CF- Dickinson TX, Region 1 Office ADA Evaluation

1502 Pine Grove Dr

Accessibility Evaluation

Report Date: 02/19/2024

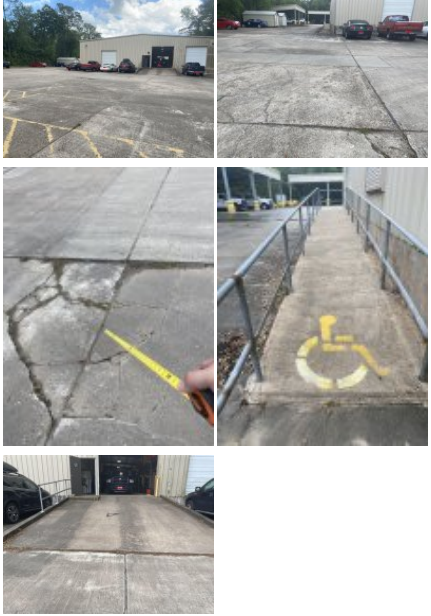
Finding Number	Area Description	Finding	As Built	Recommendation	Citation	Photos	Figure
5	Exterior of Property (Public): HQ Parking Lot (R) Side of Building (2 Spaces) 1 Van 1 Car - Car Accessible Stall	The stripe is missing at the right side of the right parking stall which identifies its border. Vehicle spaces shall be marked to define the width, and shall have an adjacent access aisle.	Striping for (R) side of accessible stall is missing. ISA insignia is dilapidated. Accessible stall dimensions meet compliance.	https://www.access-board.gov/aba/#aba-502_1 https://www.access-board.gov/aba/#aba-502_2	2012 TAS Section: 502.2 2010 ADAS Section: 502.2 2015 ABAAS Section: 502.1, 502.2	 	
6	Exterior of Property (Public): HQ Parking Lot (R) Side of Building (2 Spaces) 1 Van 1 Car - Car Accessible Stall	The parking sign is mounted too low. Parking space identification signs shall include the International Symbol of Accessibility. Signs identifying van parking spaces shall contain the designation "van accessible." Signs shall be 60 inches minimum above the finish floor or ground surface measured to the bottom of the sign.	Measures at 57"	https://www.access-board.gov/aba/#aba-502_6	2012 TAS Section: 502.6 2010 ADAS Section: 502.6 2015 ABAAS Section: 502.6

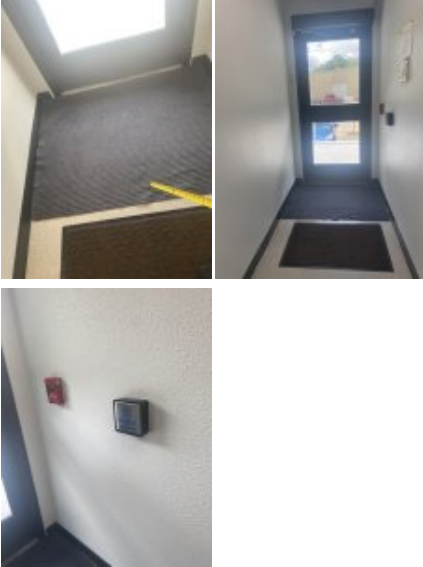
14	Exterior of Property (Public): Lab & Conference Room Building (Exterior) - TOUR - Path of Travel Ramp (L) Side Entrance	The ramps exceeds the maximum running slope (direction of travel) allowable of 8.33%. Ramps should have the least possible slope but in no case more than 8.3% (1:12).	Measures at 10.2%	https://www.access-board.gov/ada/#ada-405_2	2012 TAS Section: 405.2 2010 ADAS Section: 405.2 2015 ABAAS Section: 405.2		
15	Exterior of Property (Public): Lab & Conference Room Building (Exterior) - TOUR - Path of Travel Ramp (L) Side Entrance	The accessible route contains loose gravel and/or surface materials that do not provide for a stable, firm slip resistant surface. Floor and ground surfaces shall be stable, firm, and slip resistant.	Debris and other loose materials preventing access.	https://www.access-board.gov/ada/#ada-302_1	2012 TAS Section: 302.1 2010 ADAS Section: 302.1 2015 ABAAS Section: 302.1

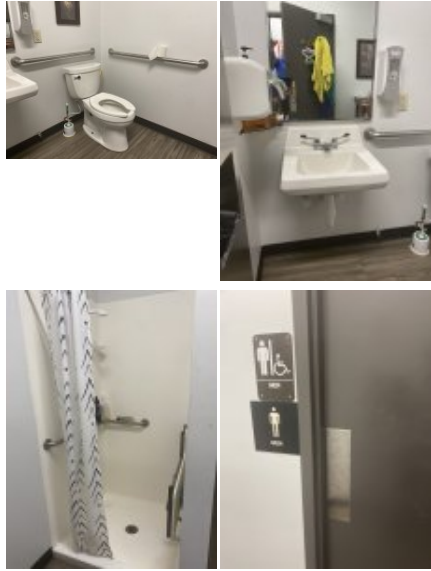
Finding Number	Area Description	Finding	As Built	Recommendation	Citation	Photos	Figure
20	Structures on Property (Public) - Tour/Public Componets : HQ Building (Interior) - Restroom (Men's) Public/Staff	The toilet paper dispenser is mounted too close to the top of the grab bar, minimizing the gripping surface. Adjacent elements shall be positioned to provide unobstructed use of grab bars. The space between the grab bar and projecting objects above shall be 12 inches minimum.	Majority of restroom componets meet compliance. One side of lavatory fully accessible. TP dispenser mounted in wrong location, impedes access. Remove clutter hanging on bar to meet compliance.	https://www.access-board.gov/ada/#ada-609_3	2012 TAS Section: 609.3 2010 ADAS Section: 609.3 2015 ABAAS Section: 609.3		
21	Structures on Property (Public) - Tour/Public Componets : HQ Building (Interior) - Restroom (Men's) Public/Staff	The water closet compartment is missing a loop handle on both sides of the door. Water closet compartments must be equipped with a door that has a loop or U-shaped handle on both sides of the door immediately below the latch. The latch must be flip-over style, sliding or other hardware not requiring the user to grasp or twist.	N/A	https://www.access-board.gov/ada/#ada-604_8_1_2	2012 TAS Section: 604.8.1.2 2010 ADAS Section: 604.8.1.2 2015 ABAAS Section: 604.8.1.2

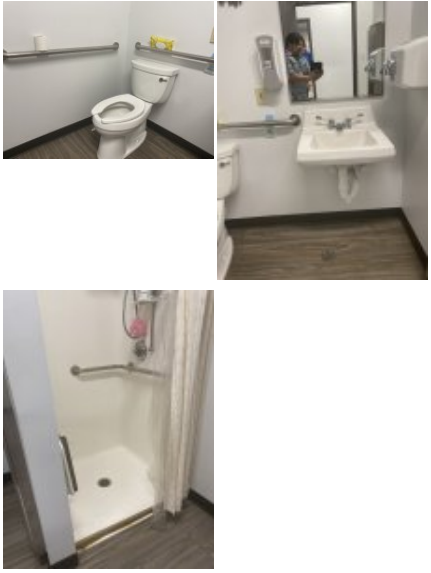
Finding Number	Area Description	Finding	As Built	Recommendation	Citation	Photos	Figure
22	Structures on Property (Public) - Tour/Public Componets : HQ Building (Interior) - Restroom (Women's) Public/Staff	The toilet paper dispenser is mounted too close to the top of the grab bar, minimizing the gripping surface. Adjacent elements shall be positioned to provide unobstructed use of grab bars. The space between the grab bar and projecting objects above shall be 12 inches minimum.	Majority of restroom componets meet compliance. TP dispenser mounted in wrong location, impedes access. Remove obstruction into restroom clear floor space.	https://www.access-board.gov/ada/#ada-609_3	2012 TAS Section: 609.3 2010 ADAS Section: 609.3 2015 ABAAS Section: 609.3		
23	Structures on Property (Public) - Tour/Public Componets : HQ Building (Interior) - Restroom (Women's) Public/Staff	The water closet compartment is missing a loop handle on both sides of the door. Water closet compartments must be equipped with a door that has a loop or U-shaped handle on both sides of the door immediately below the latch. The latch must be flip-over style, sliding or other hardware not requiring the user to grasp or twist.	N/A	https://www.access-board.gov/ada/#ada-604_8_1_2	2012 TAS Section: 604.8.1.2 2010 ADAS Section: 604.8.1.2 2015 ABAAS Section: 604.8.1.2
